Revisions to Electric Reliability Organization Definition of Bulk Electric System and Rules of Procedure; Final Rule

[Docket Nos. RM12-6-000 and RM12-7-000; Order No. 773]

Revisions to Electric Reliability Organization Definition of Bulk Electric System and Rules of Procedure

Figure 1
Two Radial Systems Eligible for Exclusion E1

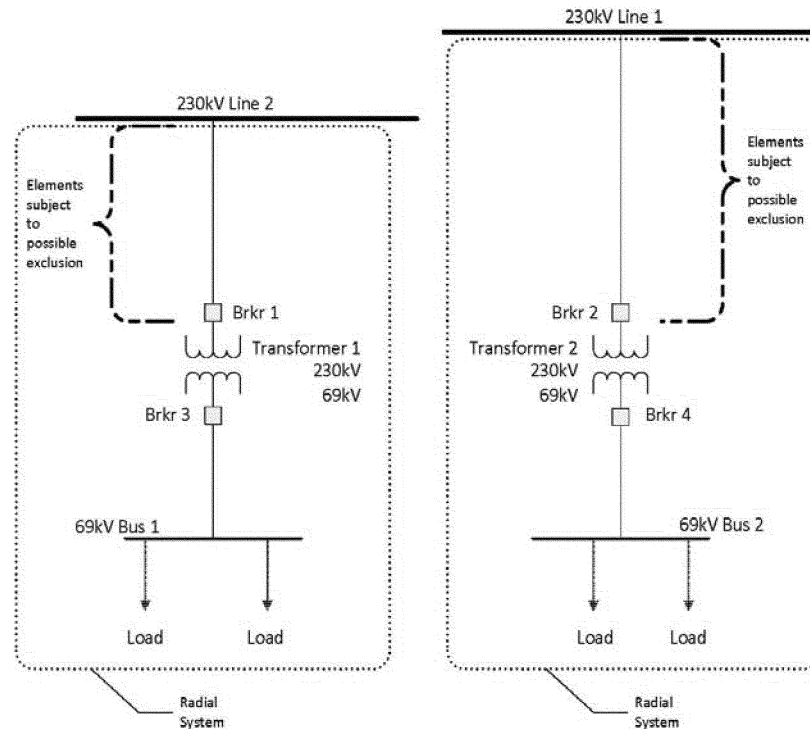
135. NERC and other commenters state that both radial systems depicted in figure 1 would be subject to exclusion E1(a) because they each only serve load.¹²⁶ ELCON agrees with NERC adding that these types of radial systems pose no reliability risk to the interconnected transmission network if the system is lost due to a fault condition. Similarly, SoCal Edison states that the figure 1 facilities would either be excluded or not part of the bulk electric system. SoCal Edison asserts that, because transformers 1 and 2 each have secondary voltages that are less than 100 kV, they do not meet the inclusion I1 requirements and, thus, are not included in the bulk electric system. In other words, SoCal Edison believes exclusion E1 should exclude all radial facilities that are greater than 100 kV up to the point where “the system is no longer radial, as indicated in figure 1 by the brackets where the 230 kV lines meet [lines 1 and 2].”¹²⁷ APPA believes that all the scenarios described by the Commission could create reliability concerns “if taken in isolation and operated in a certain matter” and

136. Anaheim agrees that the radials shown in figure 1 should be excluded and requests clarification that the associated bus work and protection system equipment installed on those radial lines are also excluded. Anaheim advocates that the exclusion should also apply to protection system equipment on the excluded facilities that provide backup protection for devices that are part of the bulk electric system, i.e. lines 1 and 2 in figure 1.

140. The Commission agrees with NERC that the radial systems shown in figure 1 meet the definition of “radial system” in exclusion E1. This configuration would result in the 230 kV lines between transformers 1 and 2 to the two 230 kV lines, respectfully, being excluded from the bulk electric system. The Commission agrees with NERC and other commenters that both radial systems depicted in figure 1 would be subject to exclusion E1 condition (a) because they each only serve load.

Figure 2
Networked Configuration w/115 kV Loop

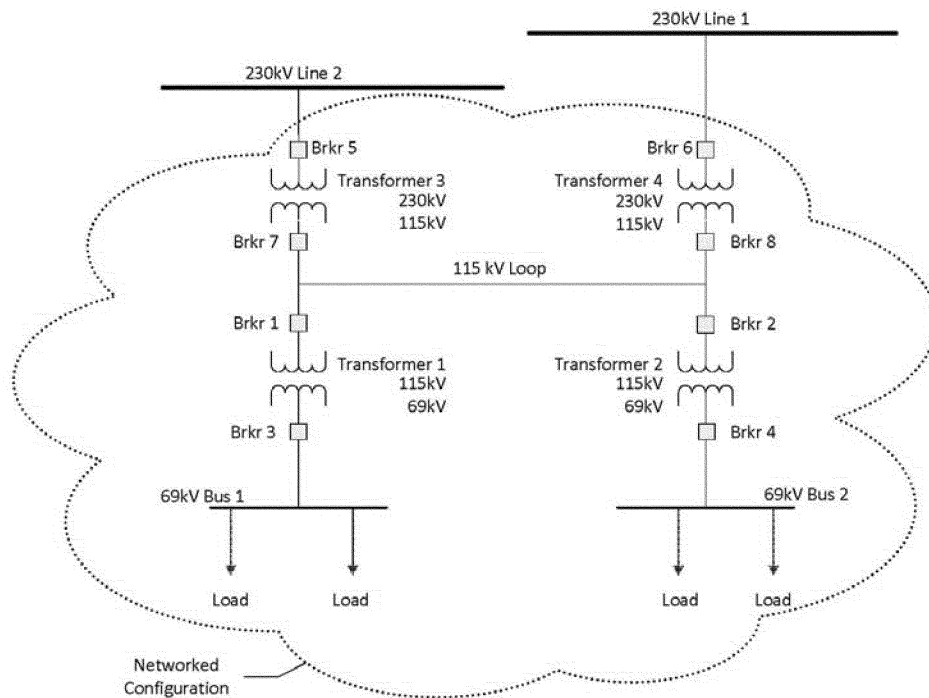
144. In the NOPR, the Commission requested comment on the scenario shown in figure 2 which shows a 115 kV loop, with the configuration emanating from two points of connection of 100 kV or higher. Specifically, the Commission requested comment on whether “the 115 kV and 230 kV elements above Transformers 1 and 2 to the points of connection to the two 230 kV lines would be excluded from the bulk electric system pursuant to exclusion E1.”¹³⁰ The Commission asked for comment on whether it is more appropriate to analyze figure 2 pursuant to the “local network” exclusion E3 and, if so, what if any elements operated at or above 100 kV would be excluded pursuant to exclusion E3.

145. NERC states that figure 2 is a non-radial loop on the 115 kV system. According to NERC, the 115 kV elements above transformers 1 and 2 to the point of interconnection with lines 1 and 2 would not be eligible for exclusion E1 because they do not emanate from a single point of connection. NERC also states that it would be appropriate to evaluate figure 2 under exclusion E3 as a potential local network.¹³¹ For such a candidate local network to qualify for exclusion, NERC states that additional technical analysis is needed to determine if all the exclusion E3 criteria are satisfied.¹³² NERC asserts that without such a technical analysis, the 115 kV elements above transformers 1 and 2 should be considered part of the bulk electric system.

146. Likewise, Idaho Power, ITC Companies, and National Grid contend that the figure 2 configuration should be included in the bulk electric system. Southern Companies believe exclusion E1 may apply from the breakers down and that the configuration may belong to

exclusion E3. AEP assumes that each of the facilities below the 115 kV loop shown in figure 2, and including breaker 1 and breaker 2, are radial and excluded pursuant to exclusion E1. According to AEP, the facilities above breakers 1 and 2 may be excluded pursuant to exclusion E3 depending on the circumstances.¹³³

147. Valero states that the figure 2 configuration is very similar to common facilities configurations employed in many industrial facilities involving the interconnection of the industrial facility to the utility through two high voltage feeder lines that originate at different utility owned and operated substations. Valero requests that the Commission include in the final rule an additional exclusion that would “categorically exclude from the [bulk electric system] any on-site high voltage switchyard facilities (less than 300 kV) owned by the industrial end-user where the predominant function of the facilities is to distribute electricity in an inward direction to the end-user’s load.”¹³⁴ WPPC argues that figure 2 shows both radial and network systems and that the system from the 115 kV loop upwards would be assessed under exclusion E3

148. The Commission affirms NERC’s statement that figure 2 is a non-radial loop and thus would not be eligible for exclusion E1 because it does not emanate from a single point of connection. The Commission agrees with commenters that the elements below the 115 kV loop should be assessed as two separate radial systems pursuant to exclusion E1. The remaining elements (the 115 kV loop, transformers 3 and 4 and the 230 kV tie lines above the transformers to the two 230 lines 1 and 2) should be assessed pursuant to exclusion E3 and if the configuration meets the criteria of exclusion E3, the elements could be excluded.

Figure 3
Networked Configuration w/69 kV Loop

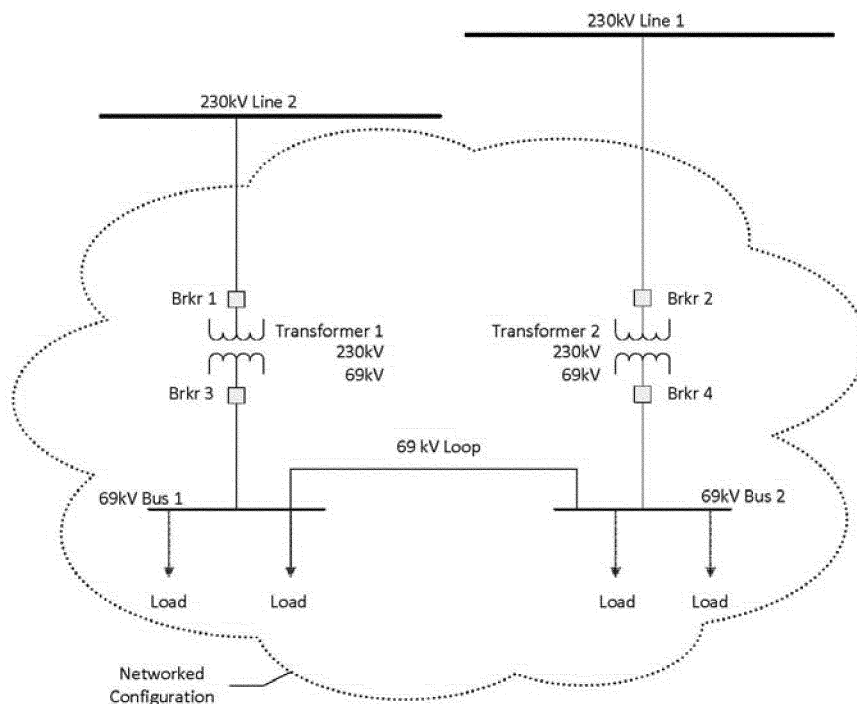
151. NERC disagrees with the Commission's characterization of figure 3 in the NOPR. NERC states that figure 3 does not depict a configuration with two points of 100 kV or higher or a system emanating from two points of connection at 230 kV. According to NERC, except for lines 1 and 2, all the other elements depicted in figure 3 are excluded from the bulk electric system. NERC explains that the elements between line 1 and transformer 2 and from line 2 to transformer 1 are excluded by exclusion E1(a) because "each separate set of [e]lements [described above] is contiguous and emanate from a single point of connection of 100 kV or higher."¹³⁷

153. Exelon agrees with NERC and explains that it has many connections similar to the one shown in figure 3 and provides a specific example where a 138 kV substation is fed by two radially connected 138 kV lines which in turn are connected through 40 MVA transformers to a 12 kV bus section. Exelon states that in its example the 40 MVA transformers cross bus sections so that if one of the 138 kV lines is out of service, each side of the 12 kV bus retains service. Exelon believes that due to the high impedance of the transformers, little energy flows between the buses in Exelon's

154. Other commenters believe that the figure 3 configuration may not be eligible for exclusion E1. SoCal Edison explains that the 69 kV loop is not open and therefore is a parallel path to the 230 kV system. BPA, Alameda and WREA do not view the figure 3 system as eligible for exclusion E1 because the system is networked. Idaho Power states that the 230 kV lines would be included only if there is a protection system in place for the 230 kV lines. According to Idaho Power, the elements above the transformers in figure 3 would not be excluded from the bulk electric system. Idaho Power believes this configuration should be evaluated under exclusion E3.

155. The Commission finds figure 3, which is identical to figure 5, is a networked configuration through a 69 kV loop and does not qualify for exclusion E1. The Commission also finds that, because the load in figure 3 can be served by either 230 kV line, it does not depict a “radial system.” However, the facilities below 100 kV may or may not be necessary for the operation of the interconnected transmission network, and this decision can be made case-by-case in the exception process. In other words, such facilities below 100 kV depicted in figure 3 would be excluded under the general threshold of the core definition unless found on a case-specific basis as necessary for the reliable operation of the interconnected transmission network. Thus, the Commission, while disagreeing with NERC’s interpretation, does not propose to include the below 100 kV elements in figure 3 in the bulk electric system, unless determined otherwise in the exception process. Further, as we discuss below in connection with exclusion E3 and figure 5, while we find that the configuration shown in figures 3 and 5 would not be eligible for exclusion E1, we believe that such configurations should be eligible for exclusion E3 for local networks. However, exclusion E3 as written requires the candidate local network to be contiguous and above 100 kV, thus, the exclusion E3 language as written does not allow for figures 3 and 5 to be eligible for the local network exclusion

because they are not contiguous *and* include facilities that are not above 100 kV. Therefore, we direct NERC to modify exclusion E3 to remove the 100 kV minimum operating voltage in the local network definition. This modification will enable configurations similar to figures 3 and 5 to be assessed for the local network exclusion. The Commission believes this modification, together with satisfying the criteria outlined in exclusion E3, will appropriately exclude local network configurations that are not necessary to the reliable operation of the interconnected transmission network.¹³⁹

Figure 5
Networked Configuration w/69 kV Loop

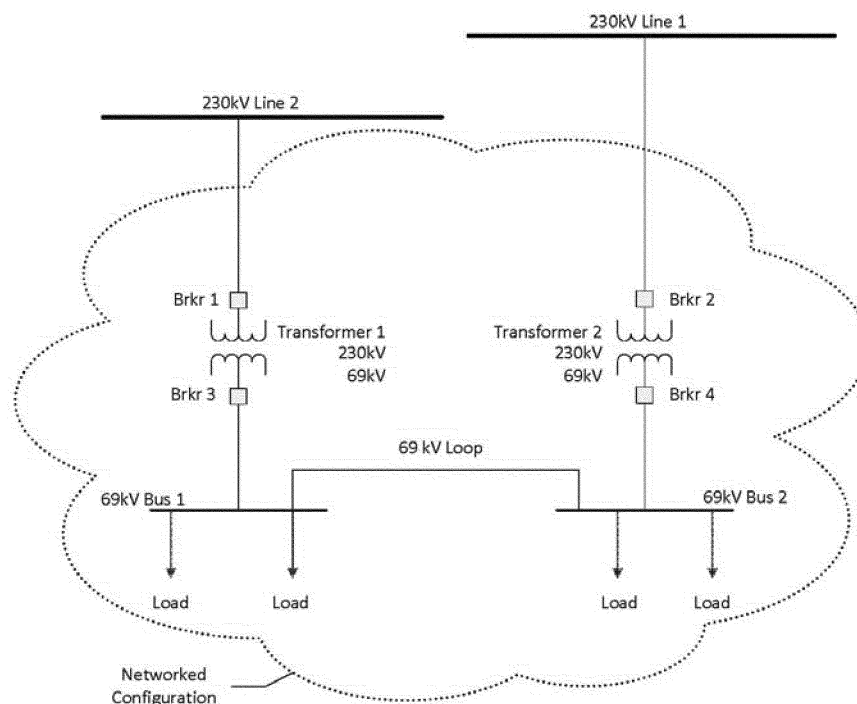
195. In the NOPR, the Commission stated that figure 5 depicts a group of elements that are contiguous through a 69 kV loop and requested comment whether the configuration in figure 5 qualifies as a local network and, in particular, whether the configuration satisfies the conditions that a local network be contiguous and operated at or above 100 kV.

196. NERC views figure 5 the same as figure 3—as a looped system below 100 kV—that is not considered under this exclusion because the elements below 100 kV are presumed to be not part of the bulk electric system.¹⁶⁷ NERC maintains that, if it is determined that the sub-100 kV looped system is necessary for the reliable operation of the interconnected transmission network, the exception process may be utilized to include the appropriate elements. NERC states that figure 5 depicts two separate and distinct groups of elements that each emanate from a

197. Exelon states that the clear intent of the definition is that configurations such as shown in figure 5 are radial systems subject to exclusion E1 (radial systems). According to Exelon, had this not been the intent of exclusion E1, exclusion E3 would have allowed for a local network where the tie was below 100 kV to avoid a reliability gap. Exelon believes that the configuration shown in figure 5, which is identical to figure 3, does not qualify as a local network within the terms of exclusion E3 and supports NERC's view that figure 5 represents two radial systems that qualify under exclusion E1. Exelon cautions that, if the Commission determines that the systems depicted in figure 5 do not qualify under exclusion E1 because of the low voltage tie and does not qualify under exclusion E3 because the tie is at low voltage and not a 100 kV or above, such a decision would leave a gap under which a substantial number of facilities that are not part of the bulk electric system

would be classified as such. Exelon states that it would have to go through the separate exception process for dozens of substations, at great cost and for no useful purpose. Exelon states that the Commission should clarify that the configuration shown in figures 3 and 5 qualifies as a radial system and is excluded pursuant to exclusion E1.

199. As discussed above, the Commission is directing a modification to exclusion E3 to better capture local networks like those depicted in figure 5. The Commission notes that Exelon believes that the configuration shown in figure 5, which is identical to figure 3, does not qualify as a local network within the terms of exclusion E3. While figures 3 and 5 are a networked configuration through a 69 kV loop, they do not qualify for the local network

exclusion because exclusion E3 defines local networks as “[a] group of contiguous transmission Elements operated at or above 100 kV but less than 300 kV that distribute power to Load rather than transfer bulk-power across the interconnected system.” The configuration in figure 5 includes elements that are below 100 kV, and does not have contiguous elements operating at or above 100 kV but less than 300 kV. As noted above, while the Commission finds that these configurations should not be eligible for exclusion E1, we believe that they should be eligible for the local network exclusion. Therefore, we direct NERC to modify exclusion E3 to remove the 100 kV minimum operating voltage in the local network definition. Within 30 days of the effective date of this Final Rule, we direct NERC to submit a schedule outlining how and when it will make the modification to the definition.
